Model: S-C4.5	Date: 26-Jan-11	No.: RD115004a
---------------	-----------------	----------------

Subject: Firmware Release Note: Engine		Prepared by: M.Ishihara	
From: 3rd Tech Service Sect., MFP/Printer Tech Service Dept			
Classification:	<input type="checkbox"/> Troubleshooting <input type="checkbox"/> Mechanical <input type="checkbox"/> Paper path <input type="checkbox"/> Product Safety	<input type="checkbox"/> Part information <input type="checkbox"/> Electrical <input type="checkbox"/> Transmit/receive <input checked="" type="checkbox"/> Other (Firmware)	<input type="checkbox"/> Action required <input type="checkbox"/> Service manual revision <input type="checkbox"/> Retrofit information <input checked="" type="checkbox"/> Tier 2

This RTB has been issued to announce the firmware release information for the **Engine**.

Old part number	New part number	Description	Q'ty	Int	Page	Index	Note
	B2621467	SHEET:DISPLAY:EXPAND:B:NA	1-1		11	15

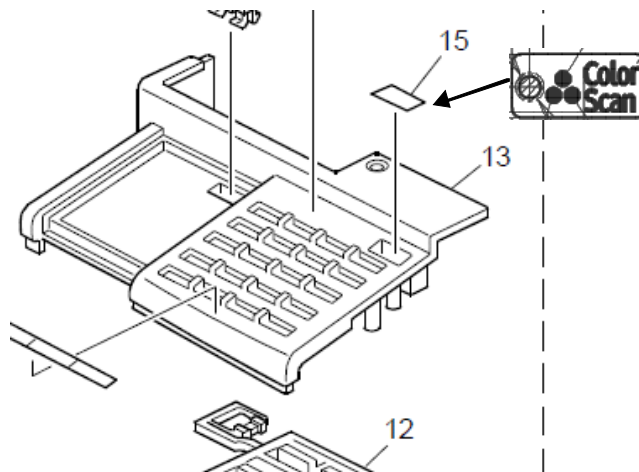
Change/Reason: The "Color Scan" decal was missing from the parts catalog.

Old part number	New part number	Description	Q'ty	Int	Page	Index	Note
	B2621458	SHEET:DISPLAY:POWER SOURCE:NA	1-1		9	18

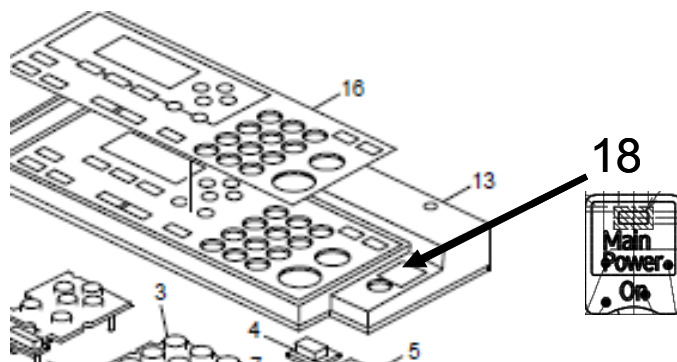
Change/Reason: The "Main Power On" decal was missing from the parts catalog.

Important Information about Changes to the PCU

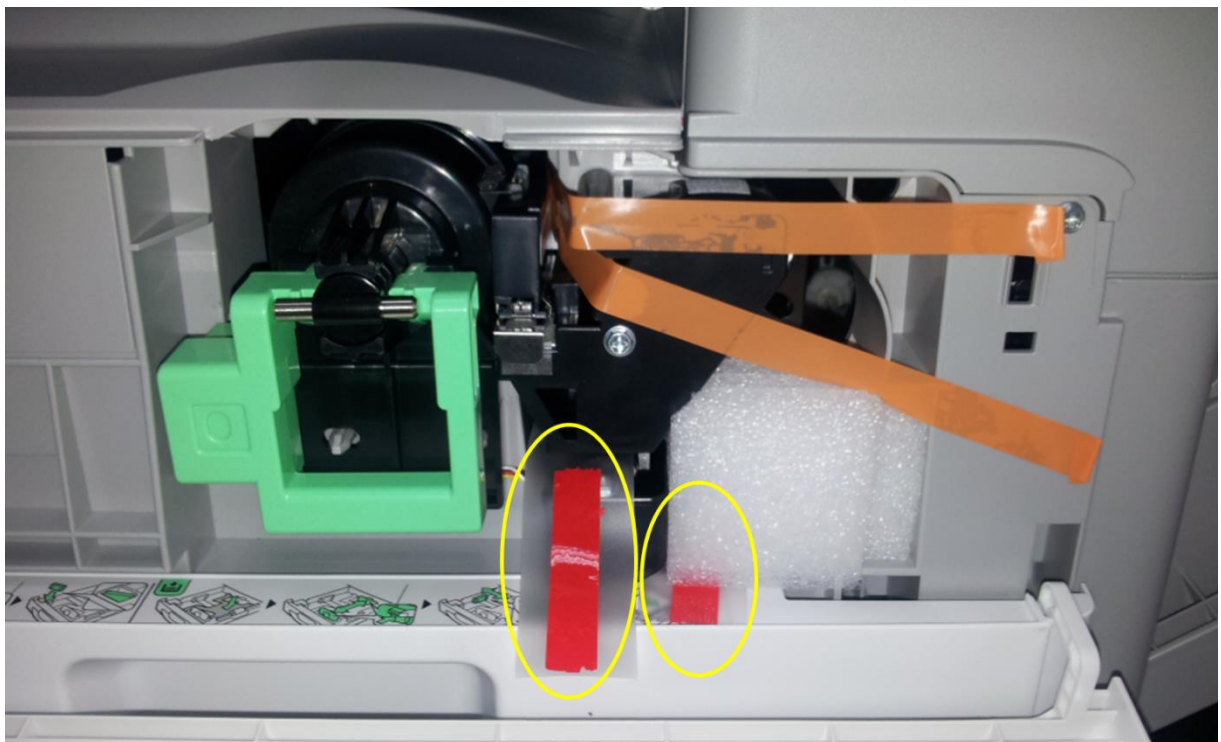
1. The strips of red tape (circled below) were changed.

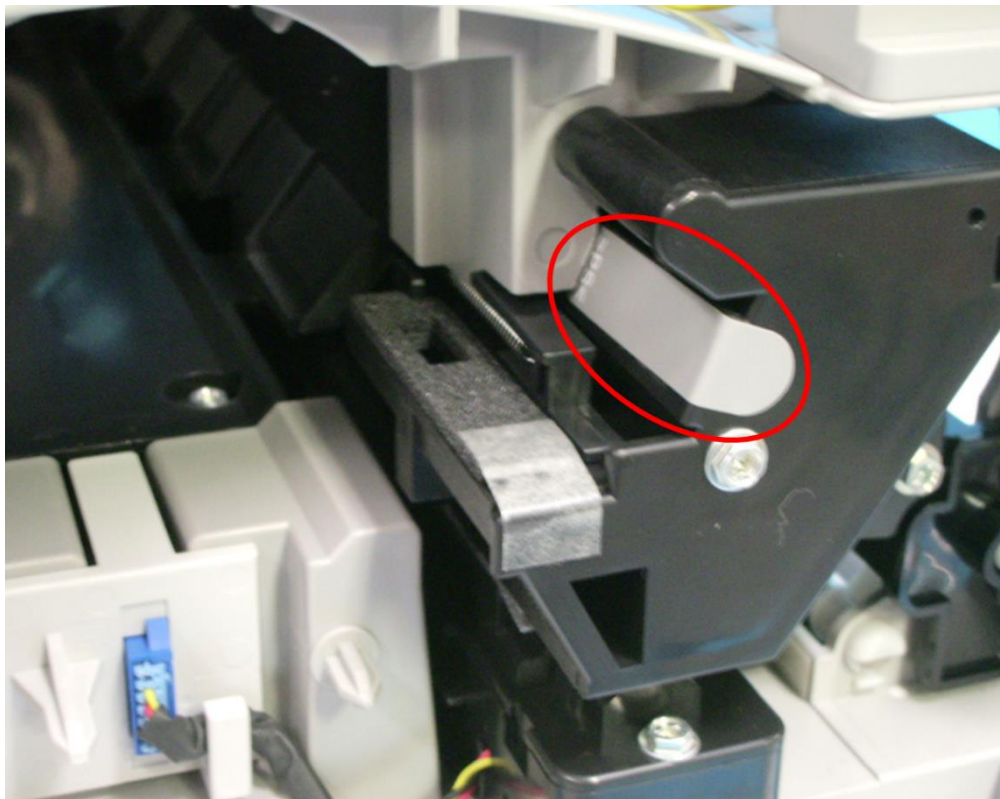
2. The seal affixed to the area circled in the photo was deleted.

Old part number	New part number	Description	Q'ty	Int	Note
D1155712	D1155713	PCB:CTL:STL-C4.5:SUB-ASS'Y	1 - 1	X/O

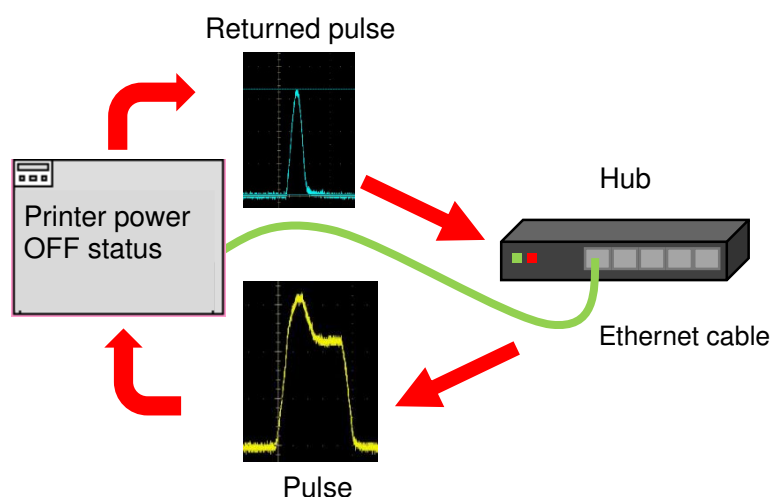
Interference in network communication may occur, if the printer is connected to a hub and the printer switch had been turned OFF (or the power cable was unplugged).

Pulse generated from hubs are transmitted to the printer while the printer is switched OFF (or unplugged). After transmitted to the printer, it then returns to the hub, causing interference in network communication.

The circuit on the Controller Board was modified.

BICU

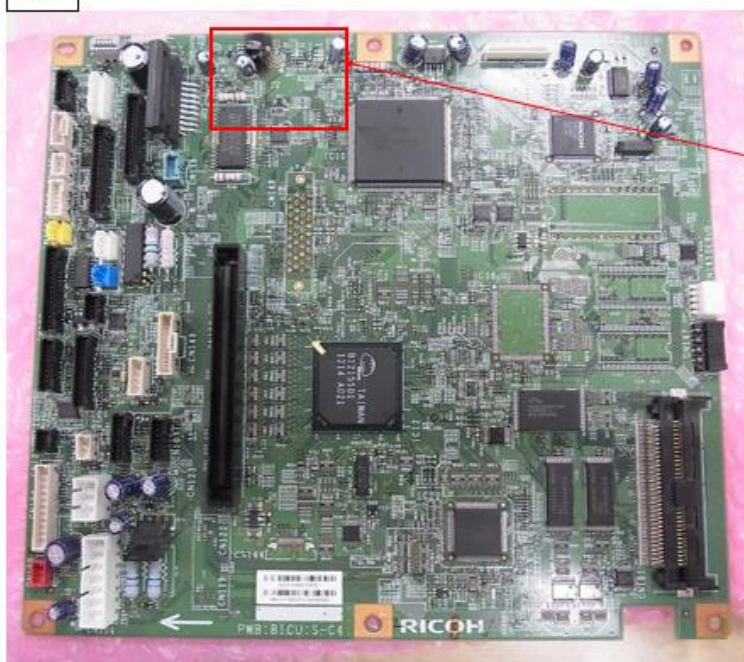
Smoke is emitted from the BICU board.

The burned portion

The harness containing 5v lines was pinched between the BICU and surrounding electrical component(s) and then damaged. This resulted in electrical stress on the IC (Q22).

Check the following harnesses of the 5v line and replace the damaged harness and BICU.

Important: Make sure that you do not allow harnesses to be pinched when you replace a harness or board.
